**CITY OF SHERWOOD
JULY 5, 2022
STAFF REPORT**

**SHERWOOD BLVD. MULTIFAMILY
SITE PLAN REVIEW / CLASS A VARIANCE
LU 2022-006 SP / VAR**

To: Chair Jean Simson, City of Sherwood Planning Commission

From: Eric Rutledge, Associate Planner

SITE PLAN

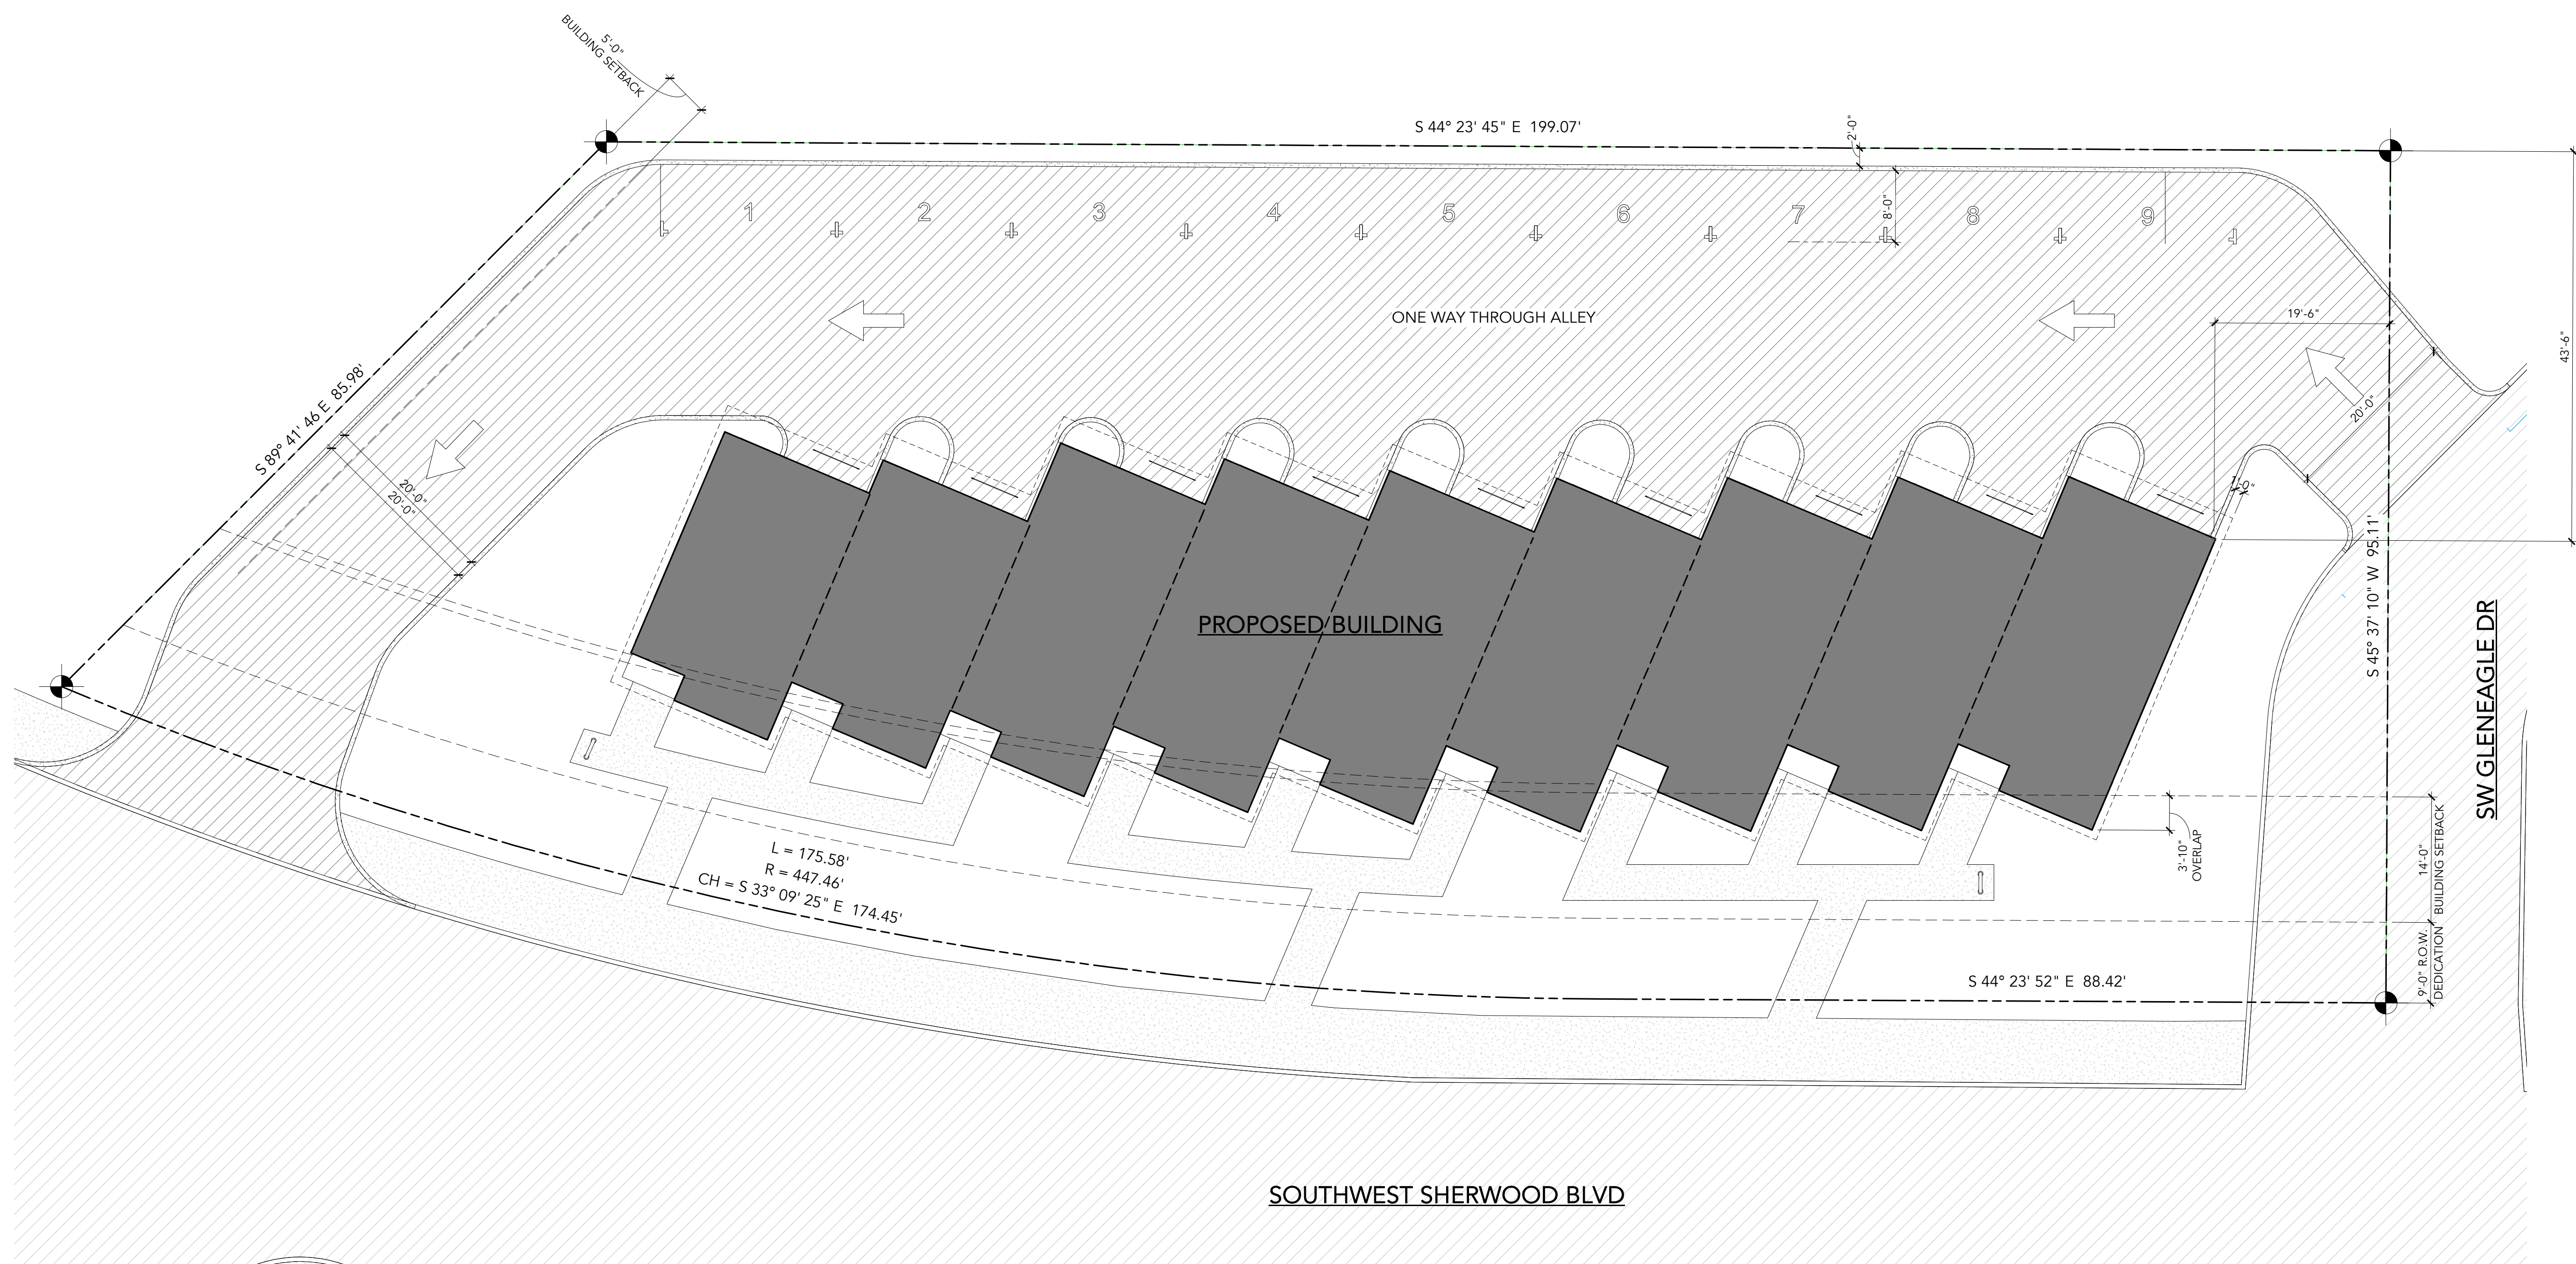
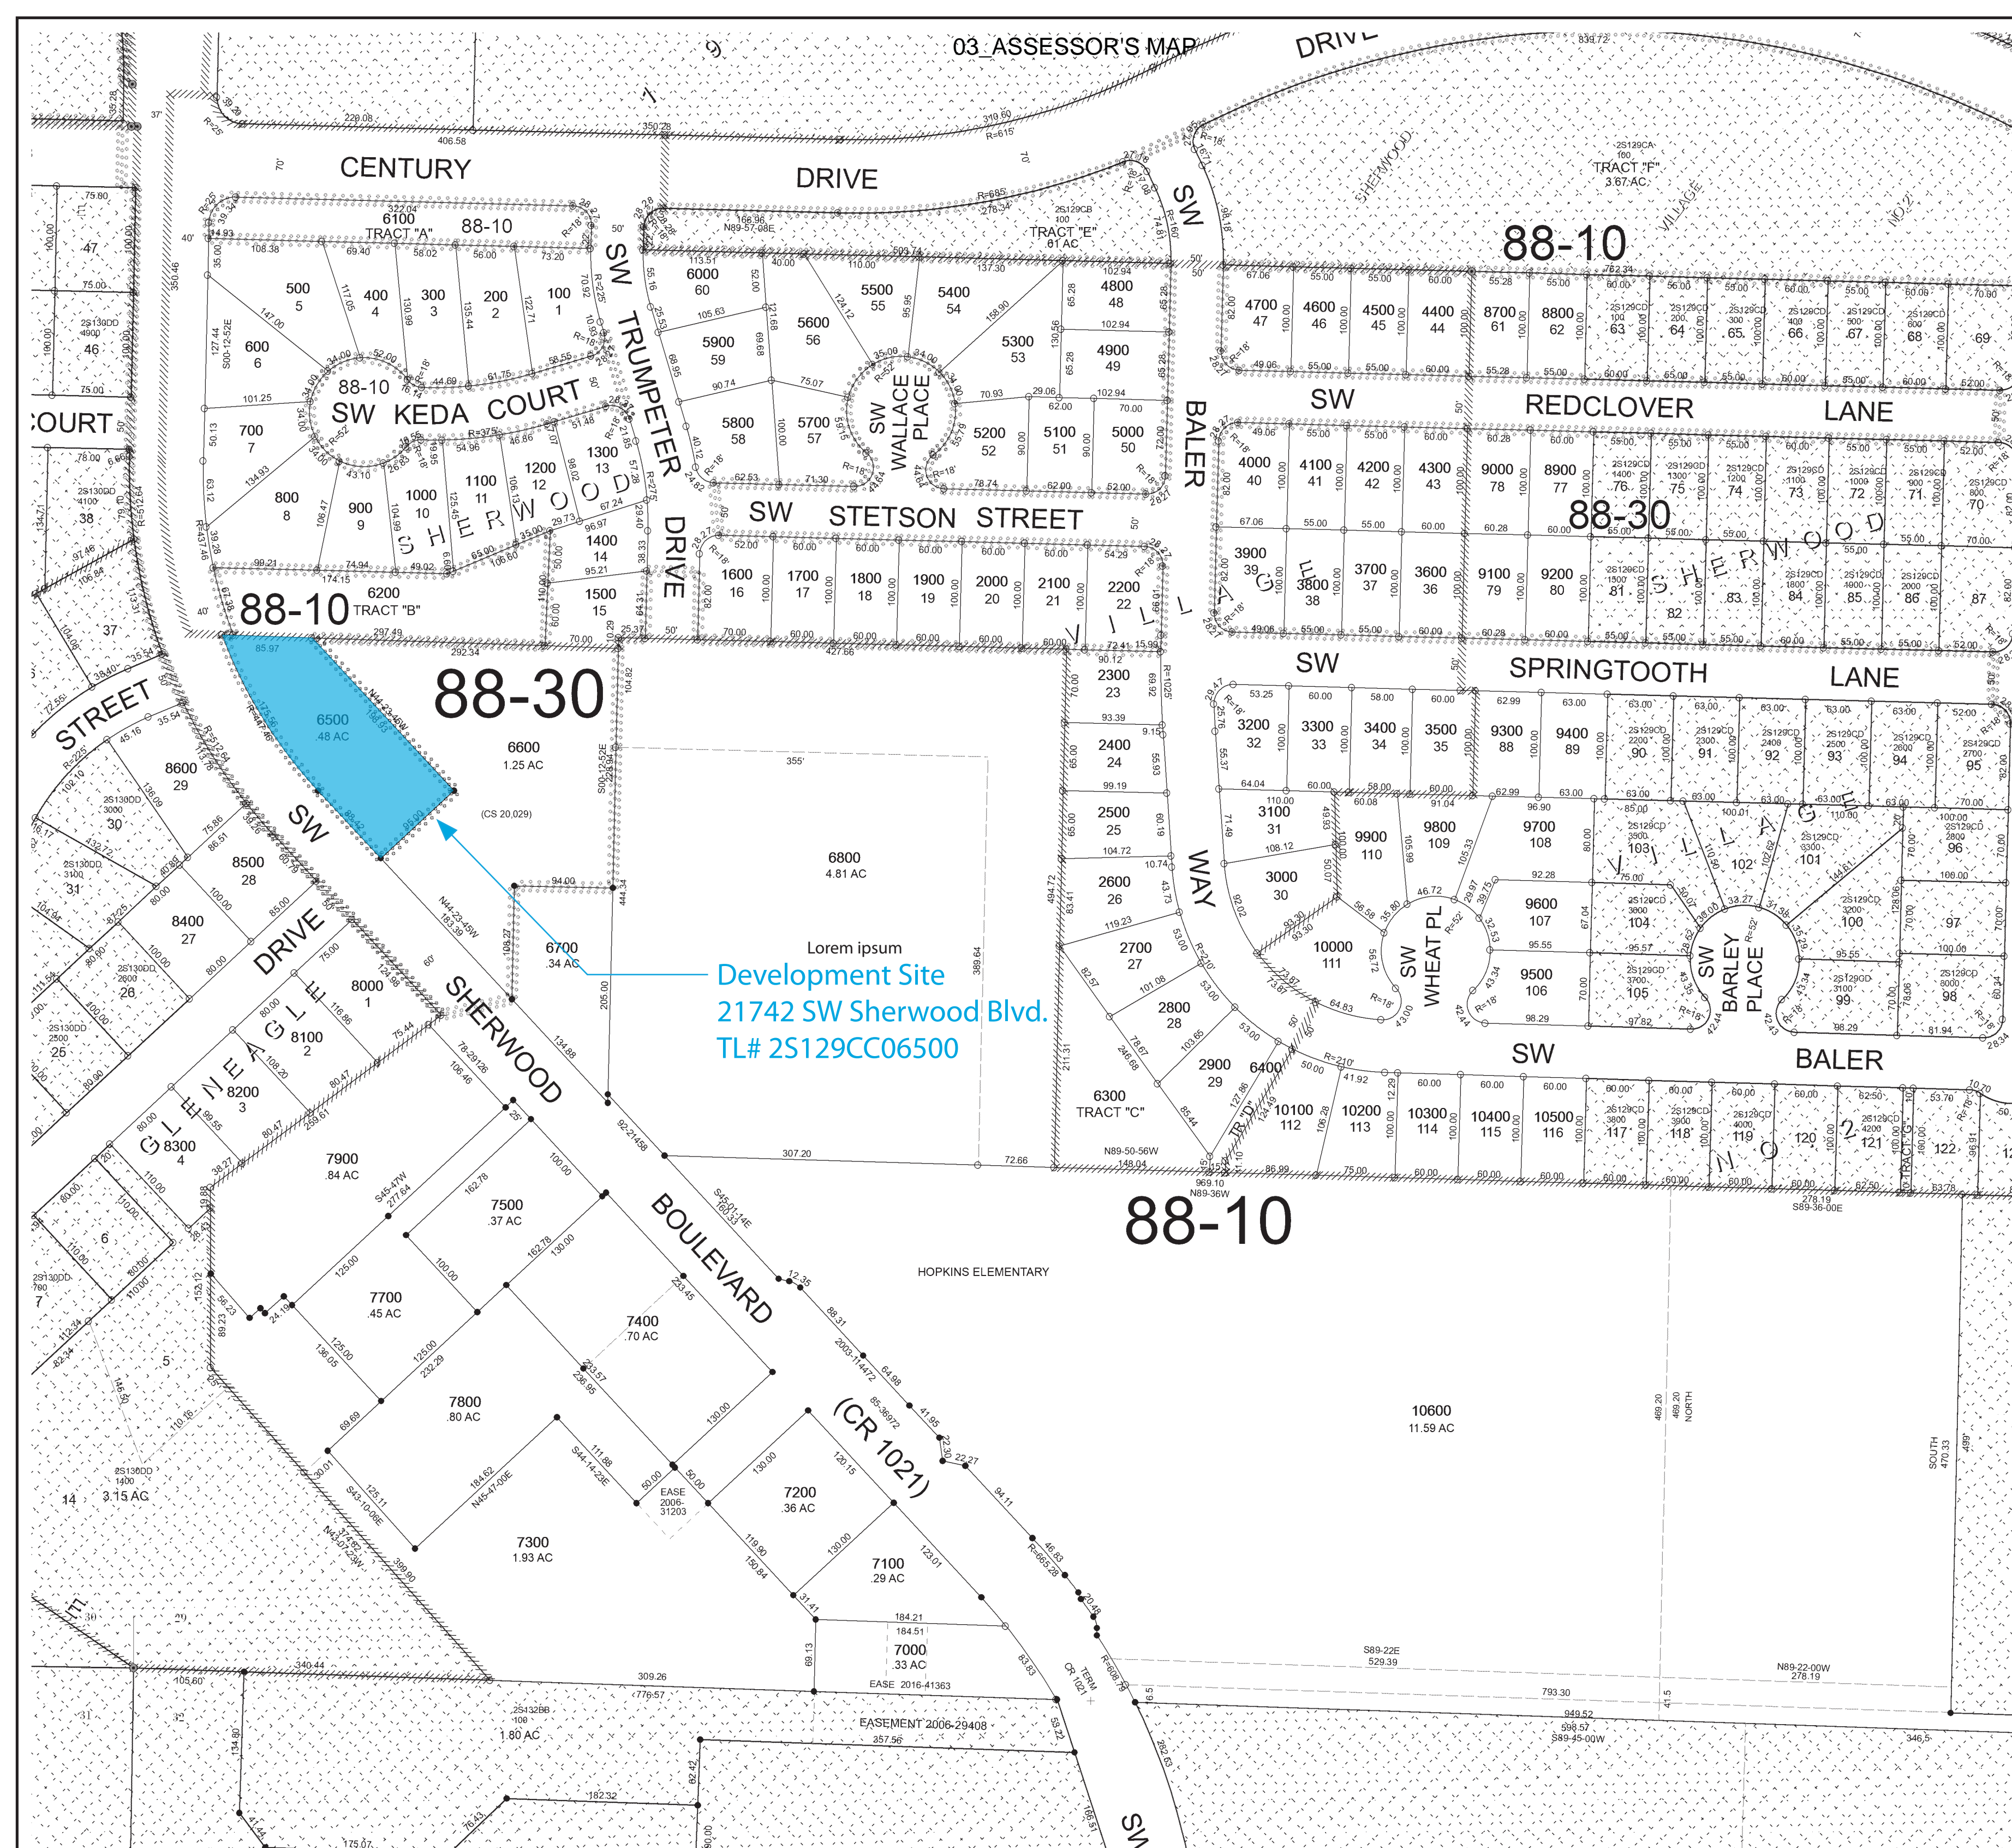
CONDITION OF APPROVAL B1: Prior to Final Site Plan Approval, revise the plans (Site Plan and Landscape Plan) to provide the required Clear Vision Areas at each driveway intersection with a public street in accordance with SZCDC § 16.58.010.

EXISTING CONDITIONS
 SCALE: 1" = 20'
 PROJECT NO: 60-16
 SHEET: 03 OF 17

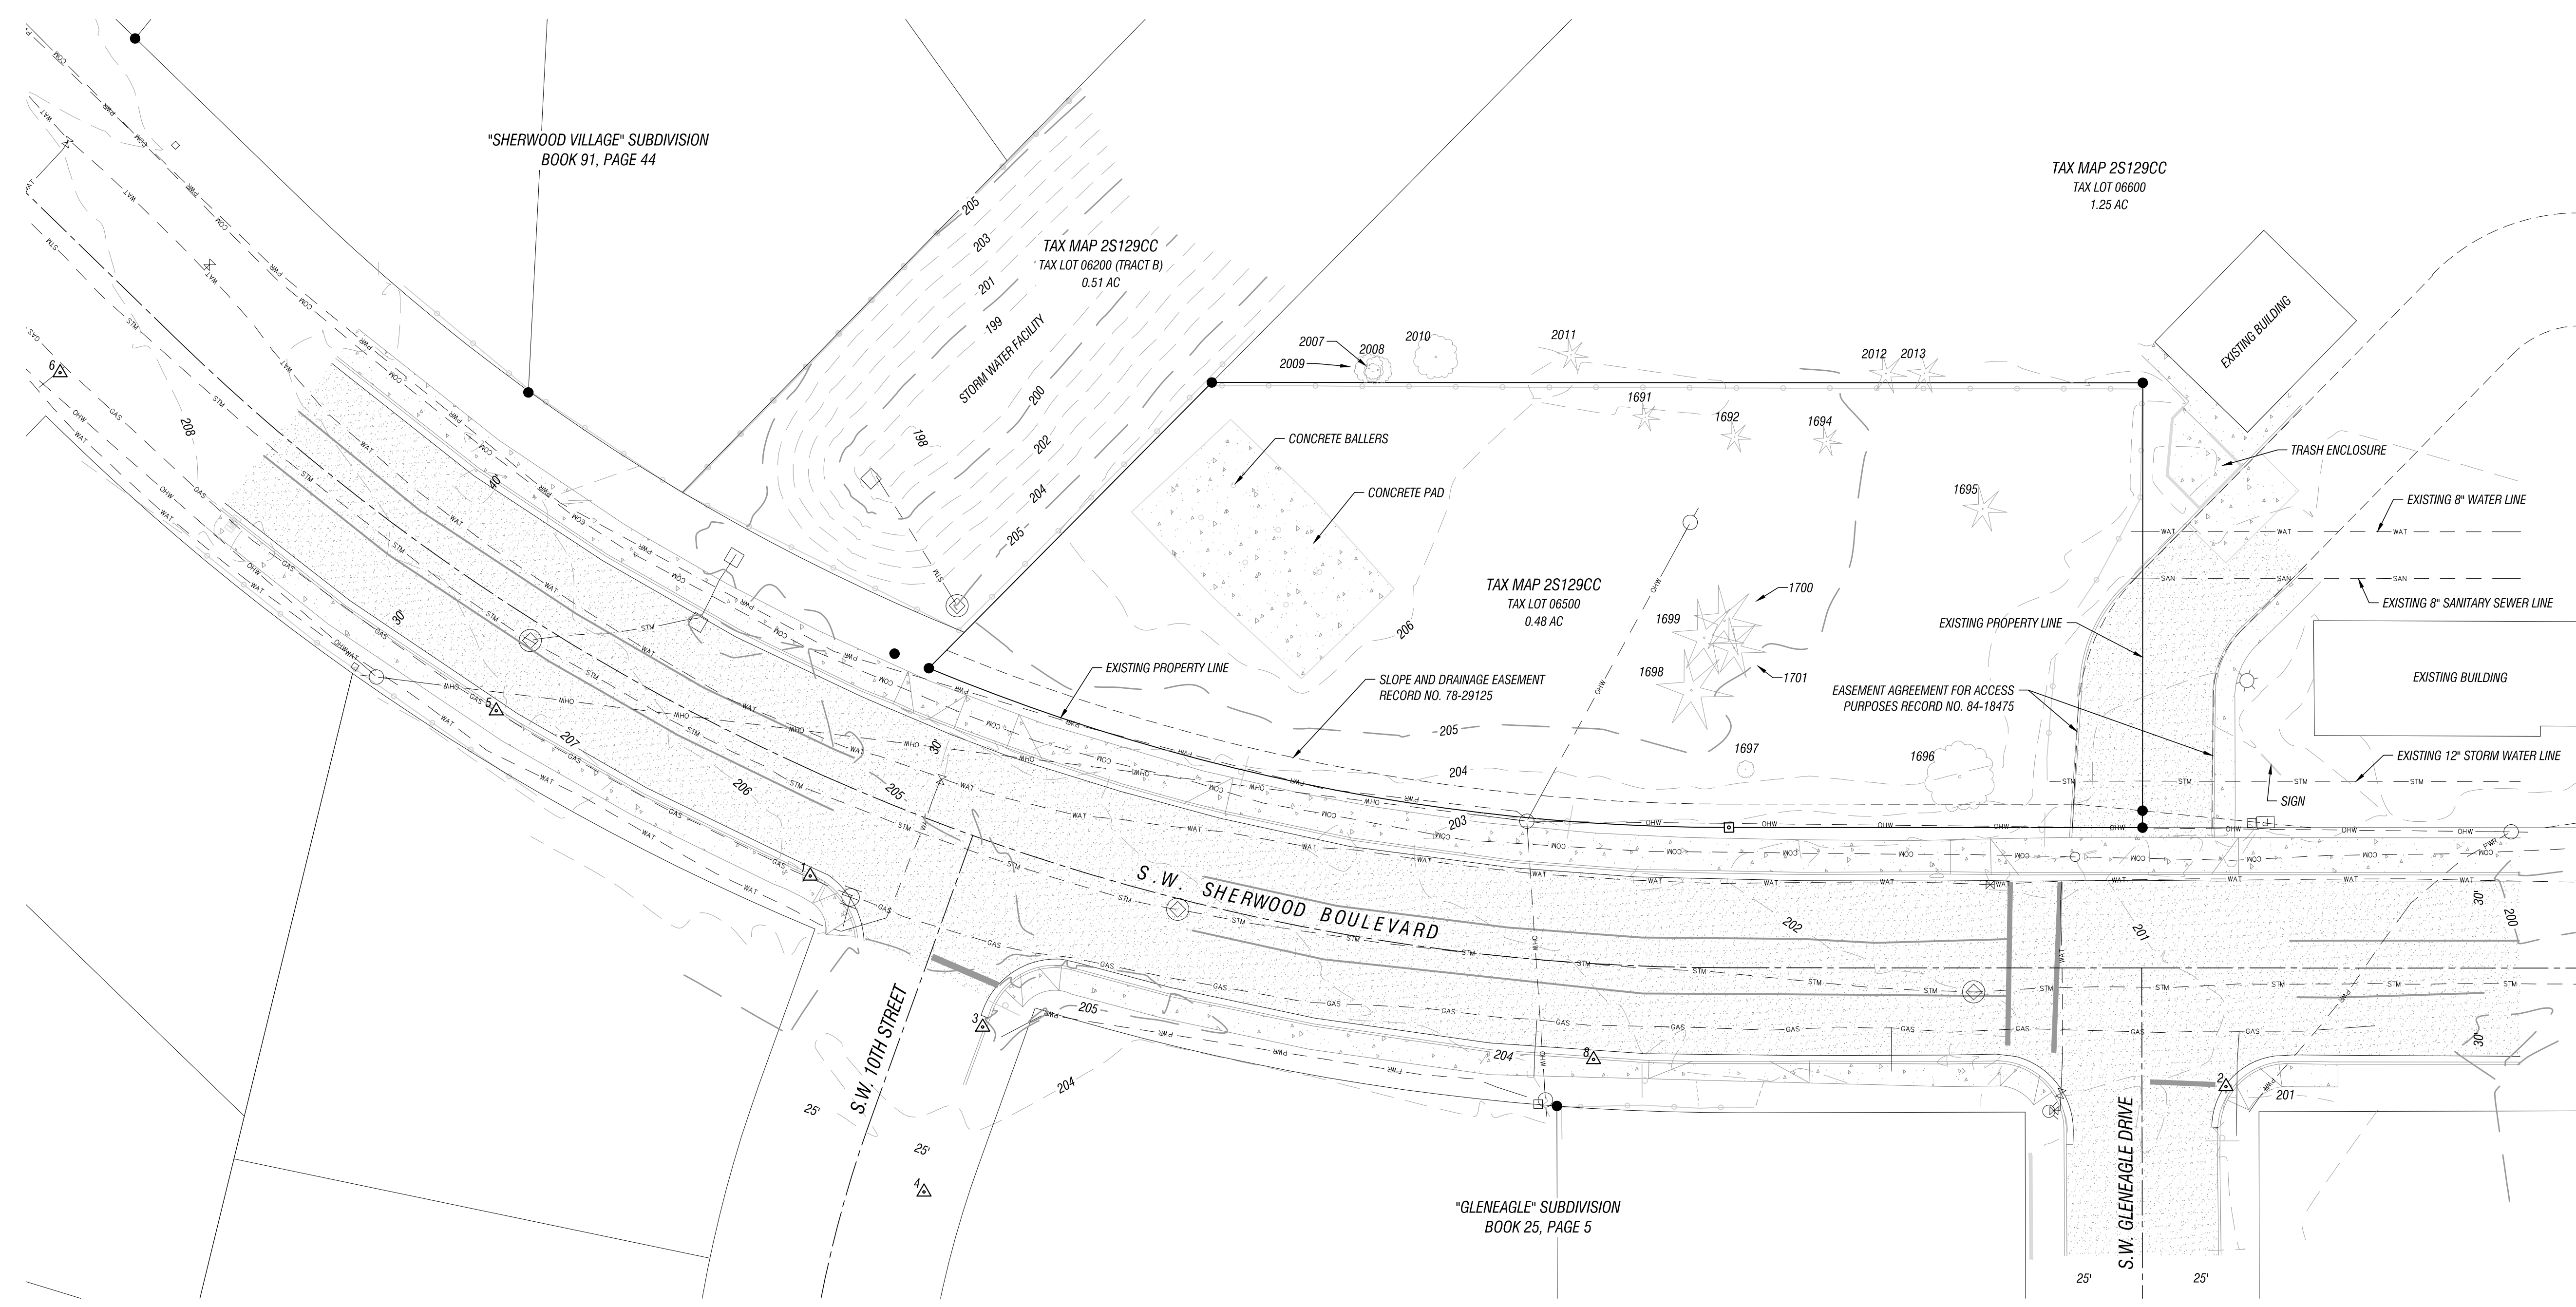
- H. Existing Conditions: The site is currently vacant except for a concrete pad from the demolished barn, a wooden pole, and overhead wires. There are 10 medium to large size trees on the property, including 4 douglas fir, 4 blue spruce, 1 freeman maple, and 1 sweet cherry (Exhibit A – Sub Exhibit

C – Sheet EX-1 Existing Conditions). The western portion of the driveway serving the Stewart Terrace Apartments is located on the subject property. Shared access for the properties is established in Doc #84018475 and Washington County Doc 2022-023363s (Exhibit A – Sub Exhibit A). Trimet Stop ID# 5247 is located along the site frontage on the north side of SW Sherwood Blvd. TriMet lines 93 and 94 provide service between Sherwood and Pioneer Square in downtown Portland.
